# **Daroobalgie Solar Farm**

## **Preliminary Hazard Analysis Report**

<b>Project name</b>		Daroobalgie Solar Farm					
<b>Document title</b>		Daroobalgie Solar Farm   Preliminary Hazard Analysis Report					
<b>Project number</b>		12583169					
<b>File name</b>		12583169-REP-PHA Report with DPE Response.docx					
Status Code	Revision	Author	Reviewer		Approved for issue		
			Name	Signature	Name	Signature	Date
S04	1	F. Duncan	M. Erskine	* signature on original	S. Martin	* signature on original	2/07/2021
S04	2	F. Duncan	M. Erskine		M. Erskine		8/06/2022
[Status code]							
[Status code]							
[Status code]

Figure 4 Proposed BESS layout

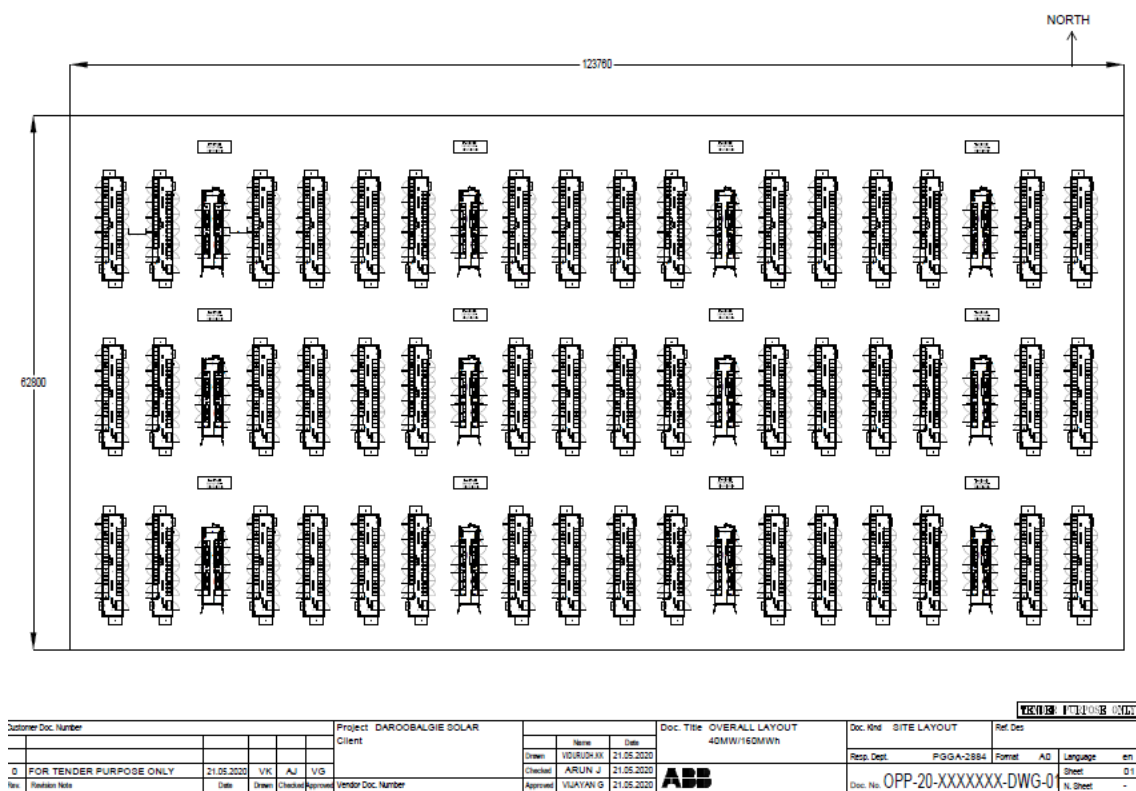
Following initial submission of the EIS, the NSW Department of Environment and Planning requested further information be provided to verify the separation distances between battery sub-units (containers, enclosures etc) are sufficient to ensure a fire does not propagate between the individual sub-units including:

1. verification that the battery energy storage system (BESS) would be accommodated within the area designated for the BESS, accounting for separation between BESS sub-units to prevent fire propagation. This verification should examine relevant codes and standards for BESS (such as NFPA 855, AS 5139, IEC 62897, UL 9540, FM Global DS 5-33) and the findings of the 2021 Victorian Big Battery fire
2. demonstrating that the fire risks from the BESS can comply with the Department's Hazardous Industry Advisory Paper No. 4, 'Risk Criteria for Land Use Safety Planning'

The project layout of the facility at this early stage of design, has the BESS located outdoors with 2 metres between open doors of individual BESS units and 2 metres between open doors of BESS units and transformer units (where relevant) (see Figure 4). The BESS is approximately 25 metres from the closest site boundary and 100 metres from administration/ maintenance buildings (as per Figure 2).

The most relevant guidance for BESS separation distances comes for United States of America. The proposed layout aligns with guidance on separation distances as set out by the most recently released codes, as shown in Table 14. The 2021 Victorian Big Battery fire is also less relevant given the proposed layout of the BESS associated with the project, however, does highlight the importance of having a functioning battery monitoring system throughout all life-cycle periods (including commissioning). Additionally, the findings from the Victorian Big Battery fire indicate that appropriate thermal testing is needed when determining final BESS layout.
